2.0 Dana Axle Lubricant Drain

Bulletin Name: FDM-TSIB-027

Model: Oshkosh S-Series

Units Affected: 2.0 Front Discharge Mixers

Figure 1

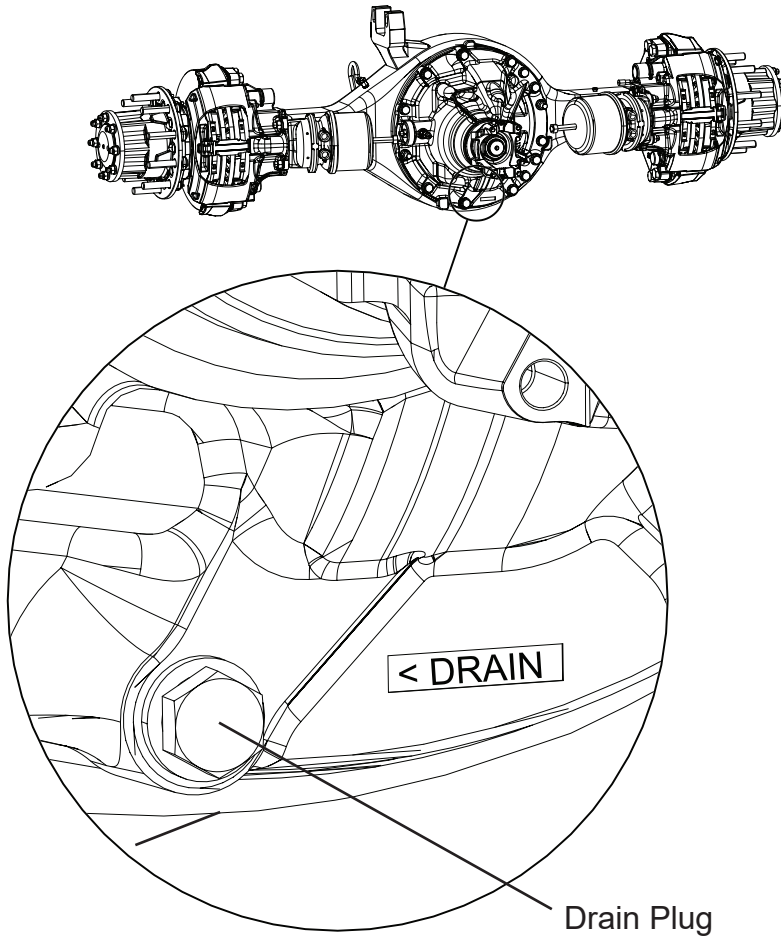
Upon release of the Dana Series 172 and 175 axles, the lubricant drain hole/plug was incorporated into the carrier of the axle assembly, see Figure 1. Dana eliminated the bottom drain hole/plug in the axle housing bowl to avoid a potential leak path.

Drain the lubricant from a Dana Series 172 or 175 axle using the drain hole/plug located in the carrier of the axle assembly.

Drain plug torque: 250 ± 15 ft. lbs.
